TECHNICAL SPECIFICATION 312

**PROPOSED TECHNICAL SPECIFICATION CHANGE  
BROWNS FERRY NUCLEAR PLANT  
UNIT 1**

**(TVA BFN TECHNICAL SPECIFICATION AMENDMENT 312)**

### BROWNS FERRY NUCLEAR PLANT (BFN) UNITS 1, 2, AND 3 (TVA BFN TECHNICAL SPECIFICATION AMENDMENT 312) REASON FOR THE CHANGE, DESCRIPTION AND JUSTIFICATION

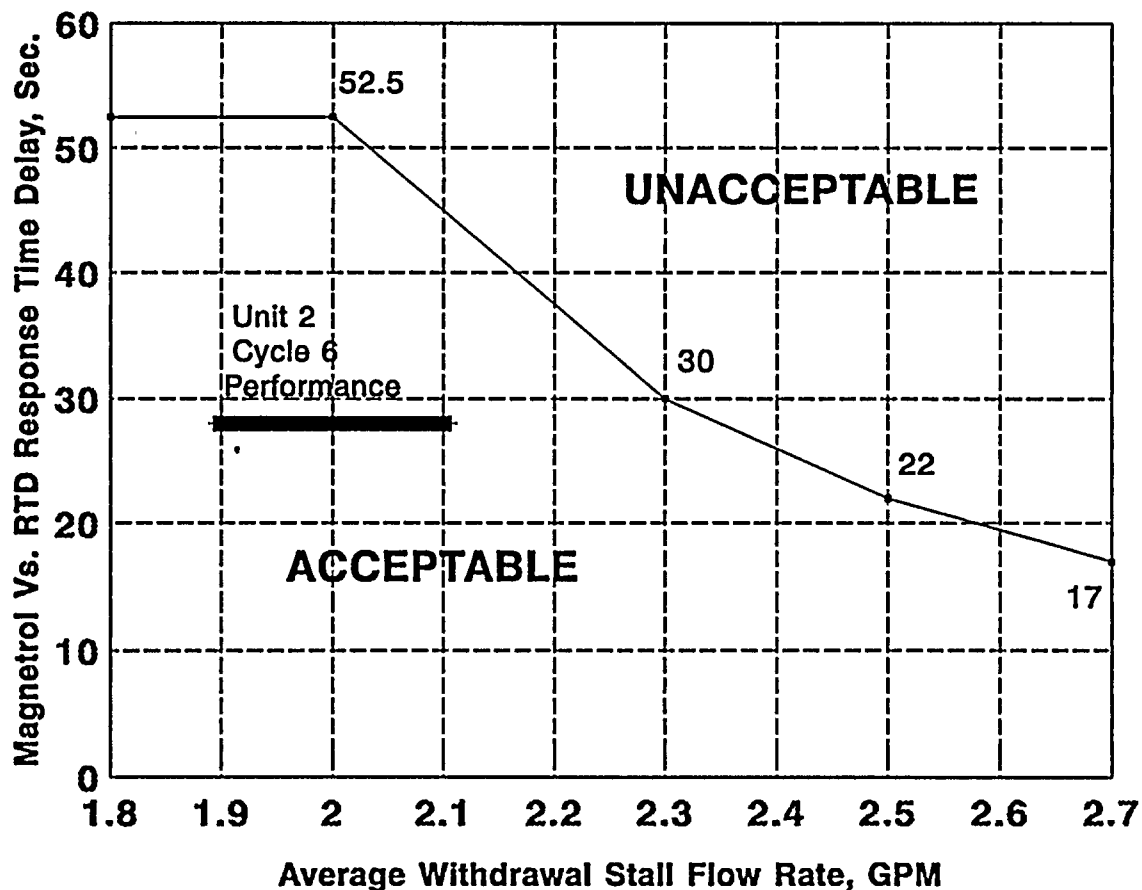
The reanalysis concluded that a successful Unit 2 scram would be achieved, with the level instrumentation and without the scram pilot air header pressure trip switches scram function, provided that the CRD leakage rate and the water level instrumentation response characteristics remain within the success criteria region shown below:

The Magnetrol Versus RTD Response Time Delay is the maximum allowable time delay between the RTD and Magnetrol level switches as measured following a reactor scram. The maximum allowable response time delay for either the East or West scram discharge instrument volume is defined as the maximum delay between any RTD level switch and any Magnetrol level switch for that scram discharge instrument volume.

The Average Withdrawal Stall Flow Rate is the CRD stall flow rate averaged over all fully withdrawn rods.

As shown on the above figure, during Unit 2 Cycle 6, the average stall flow leakage was 1.9 to 2.1 gpm per CRD. The maximum response time delay between the RTD and Magnetrol level switches for either scram discharge instrument volume was less than 28 seconds. This combination of stall flow rate and instrument delay is well within the acceptable region.
